PROJECT NAME: BINAK OILFIELD DEVELOPMENT/SURFACE FACILITIES GAS COMPRESSOR STATION

DRAWING TITLE: GENERAL ARRANGEMENT FOR GLYCOL REFLUX CONDENSER (E-100)

SCALE	SIZE	DRAWING NO.	SHEET NO.	REV.
NTS	A3	BK-GCS-MF-120-ME-DW-0017	1 OF 1	V00

ELEVATION VIEW

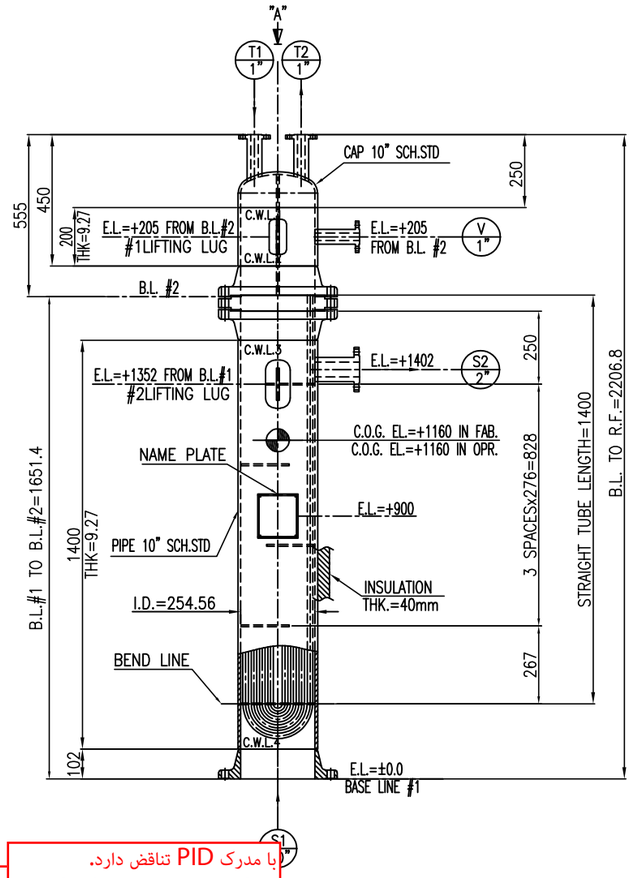
می بایست جهت بررسی مدرک 3D Model ارسال گردد.

setting bolt?
MFS: THIS EQUIPMENT INSTALL ON STILL COLUMN C-200 FROM S1 NOZZLE (NOTE 24)

MFS: 3D MODEL IS PREPERING AND WILL BE ISSUED LATER
